Access Compliance Report Public Rights-of-Way (Curb Ramps)

Intersection ID: 23101 Main Street: LYNBRIDGE_DR Cross Street: PROVIDENCE_RD Location: NW

ADA ID: 170C000A8C24 Ramp Type: Perp Initial Pass/Fail: Fail Overall Compliance: No Severity Score: 13.75

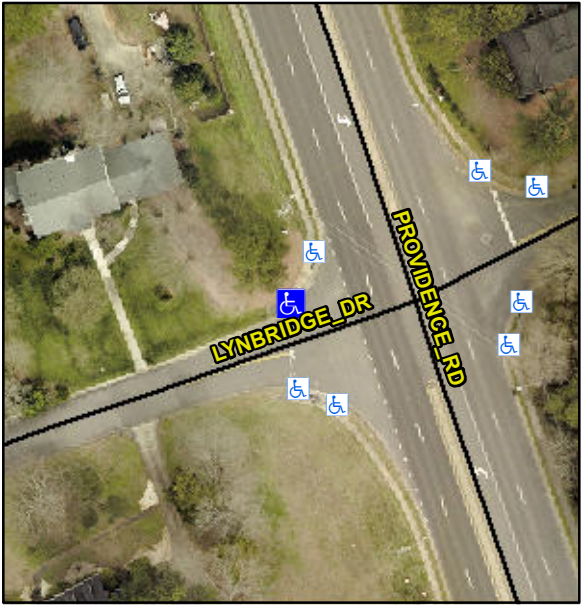
PROW/ADA:
R304.2.2, R304.5.3

Compliance	Description	Data	Compliance	Description	Data
N/A	Ramp Length (in)	72.0	No	Ramp Slope (%)	9.2
Yes	Ramp Width (in)	50.0	No	Ramp XSlope (%)	4.9
N/A	Flare Type LT	N/A	N/A	Flare Type RT	N/A
N/A	Flare Slope LT (%)	N/A	N/A	Flare Slope RT (%)	N/A
N/A	Flare Traversable LT?	N/A	N/A	Flare Traversable RT?	N/A
N/A	Landing Length (in)	N/A	N/A	DWS Provided?	N/A
N/A	Landing Width (in)	N/A	N/A	DWS Contrast?	N/A
N/A	Landing Slope (%)	N/A	N/A	DWS Length (in)	N/A
N/A	Landing X Slope (%)	N/A	N/A	DWS Full Width?	N/A
N/A	Landing Curb? (Y/N)	N/A	N/A	DWS Offset (in)	N/A
N/A	Shared Landing?	N/A			
N/A	Gutter Ponding?	N/A	N/A	Gutter Slope (%)	N/A
N/A	Gutter Lip Ht (in)	N/A	N/A	Gutter X Slope (%)	N/A
N/A	Painted X Walk1?	No	N/A	Painted X Walk2?	N/A
	X Walk 1 Direction	To S		X Walk 2 Direction	N/A
N/A	X Walk 1 Width (in)	N/A	N/A	X Walk 2 Width (in)	N/A
	X Walk 1 Slope (%)	4.0		X Walk 2 Slope (%)	N/A
	X Walk 1 X Slope (%)	0.6		X Walk 2 X Slope (%)	N/A

Possible Solutions:
Remove & Replace Entire Ramp.
